INDEXED WRITTEN FEEDBACK TO LISTENING SESSION : SPRING 2024

The following document summarizes our comments on the 2023 Massachusetts Commercial Stretch Energy Code. We include 19 comments. Each comment provides general background commentary and recommendations.

Comment 12. C402.1.4.1.1 Tapered, above-deck insulation based on thickness.

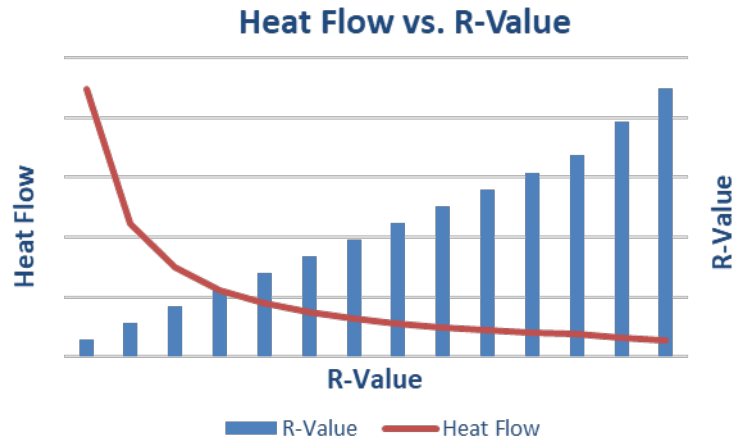
General Comment: Section C402.1.4.1.1 allows the R-value at the “average thickness” of tapered, above-deck insulation to be used in U-factor for compliance with Section C402.1.4. Using the R-value at the average thickness of tapered insulation to calculate the U-factor for an entire roof area is not representative of the actual thermal performance of the roof and allows roofs with tapered insulation to be significantly less energy efficient than the previous code versions required and significantly less energy efficient than roofs with continuous flat-stock insulation.

The heat flow through roof insulation is non-linear. As seen in the chart below, heat flow is inversely proportional to the R-value of insulation. There is a diminishing return of adding insulation beyond a certain plateau in heat retention performance, and therefore, the heat retained in areas of increased thickness of insulation (high points) is not equal to the heat lost in areas of reduced thickness of insulation (low points). Using the average insulation thickness assumes a linear relationship and inaccurately represents the actual thermal performance of the roof insulation.

In addition, Section C402.2.1.2** allows the above-deck roof insulation to taper down to as little as 1 in. without quantifying the impacts of this reduction on the building energy use. With this language, for example, you could have 1 in. of insulation at a low point and 10 in. at a high point, and the average R-value would be the equivalent of 5.5 in. of insulation. However, the heat loss through the areas with 1 inch of insulation will be much greater than the heat savings gained in areas with 10 inches of insulation, so the actual energy efficiency is not equivalent to that of a roof with a 5.5 in. of insulation.

- For roof insulation with tapered insulation, the insulation thickness used to demonstrate compliance with the prescriptive maximum U-factor should be the minimum thickness (not average thickness), with an exception allowing tapered insulation to locally taper to 1 in. less than the base thickness, consistent with previous versions of the IECC (e.g., Section C402.2.1, Exception 2 of the 2018 IECC).
- With the change described above, Section C402.2.1.2 is no longer needed. We recommend deleting that section.

Delete section.

Cape House with New Basement

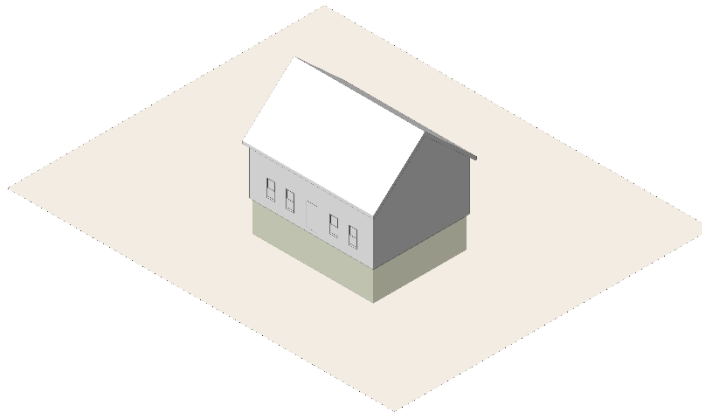
Many homes of this style are small in size. To gain more space, an owner may want to finish an unconditioned basement being 1,000 sf or matching 100% of the existing floor. These types of projects would be eliminated as most homeowners cannot afford to, and/or do not want to, renovate the majority of their existing home.

Cape House with Second-floor Addition

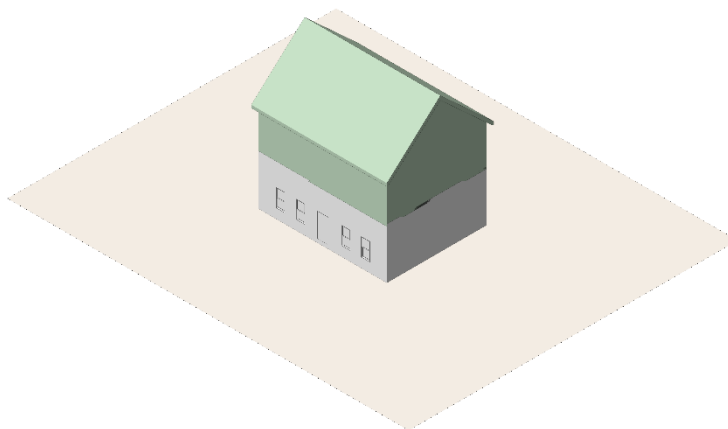
Many Massachusetts homes are Cape-style homes. Many of these homes were built post-WW2 and are still purchased as ‘starter homes’. Initially many of these homes were renovated to upgrade the kitchen, bathroom(s), HVAC and/or insulation. A typical “next phase” for a growing family would be to add a

second floor. This second floor would match the floor size below being 100%, and could meet the 1,000 sf requirement/cap. In general, homes that had been updated already were done under a renovation permit following possibly the 2009 IECC and would now required to follow either the 2015 IECC or 2021 IECC. This forces the owner to remove any already-upgraded elements (i.e. windows, insulation, etc.) and redo them. This turns what was a second-floor addition into a whole-home remodel, and makes the project no longer viable. As such, these homes are left with then with fossil fuel HVAC systems and dated insulations.

Large House with New Addition

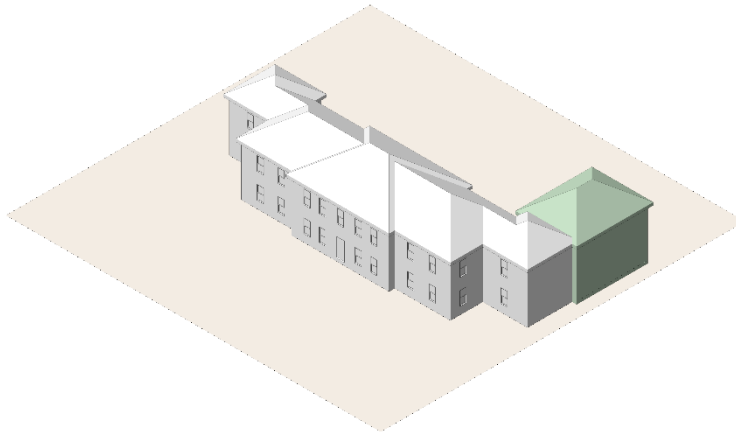
Regarding a home that is larger in size, an appropriately-scaled addition could easily be over the 1,000 sf. Again, turning a relatively smaller project into a whole-home renovation. Additionally, the existing home may have newer windows, insulation, and HVAC but might not meet the newest Stretch Code criteria but did meet. The new addition as stated above would then force a HERS rating for the entire home and such a scaled home would be very costly. This has been leaving these types of projects abandoned and a large carbon footprint home without needed updates.

Large House with New Basement

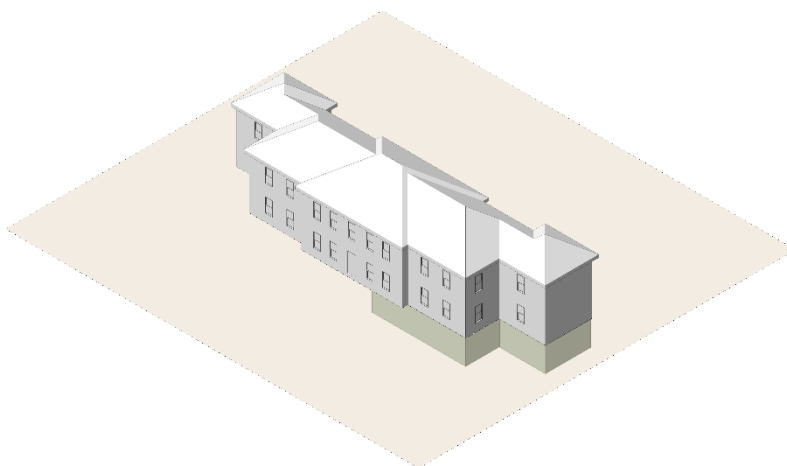
As with the above example, converting an existing basement in a larger home into additional living space may exceed the 1,000 sf. requirement. The need for additional space for a family would trigger the same issues as represented above leaving abandoned projects and an inefficient existing home due to costs to renovate the entire home.

Ranch House with Slab on Grade

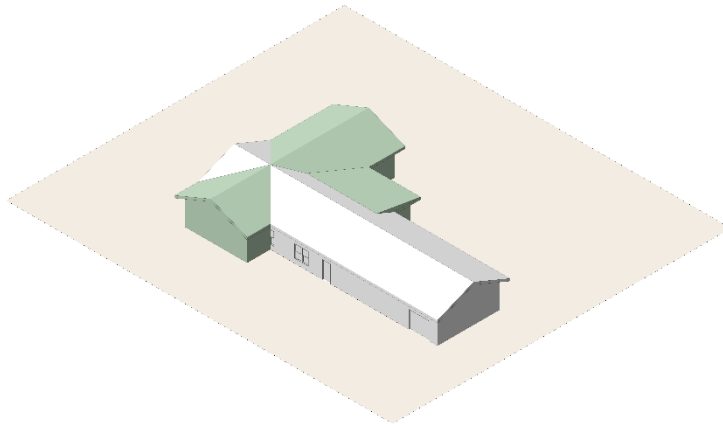
Many ranch homes were built between the 1950's – 1970's as a 'slab on grade'. These homes also often have minimum ceiling heights, rafter depths being only 5 ½" and walls only 2 ½" deep. It has been found, with the new Stretch Code, that it is not financially viable to simply put an addition on this style home. Due to the need to insulate the floors, and not raise the ceiling heights, a majority of these homes would simply be torn down.

This would most-likely irradicate a very popular and recognized version that is indicative, and was started in Massachusetts – the Campanelli Home. There were approximately 15,000 of these homes built by the Campanelli brothers in Massachusetts.

Small House Addition

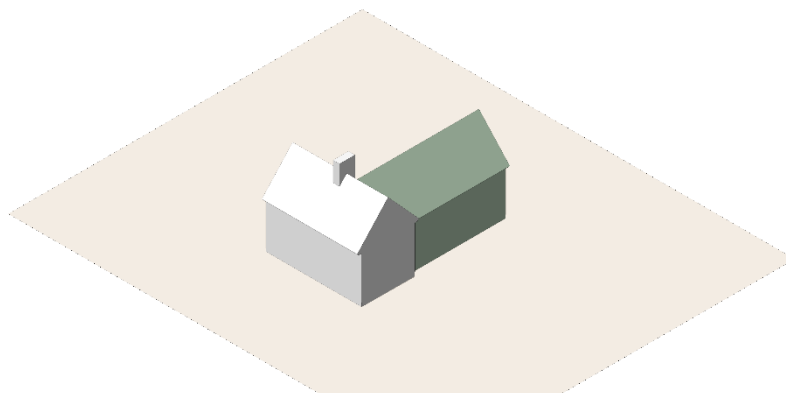
There are a majority of small homes that are less than 1,000 sf. Many of these were “starter homes” at one point. Some of these, similar to the Cape home mentioned above, were previously renovated with newer materials, but that might not meet the new Stretch Code. An addition to gain more living space could then a project into a whole-home renovation, which could make this hoped-for renovation non-viable. As such, these homes are left with then with fossil fuel HVAC systems and dated insulations.
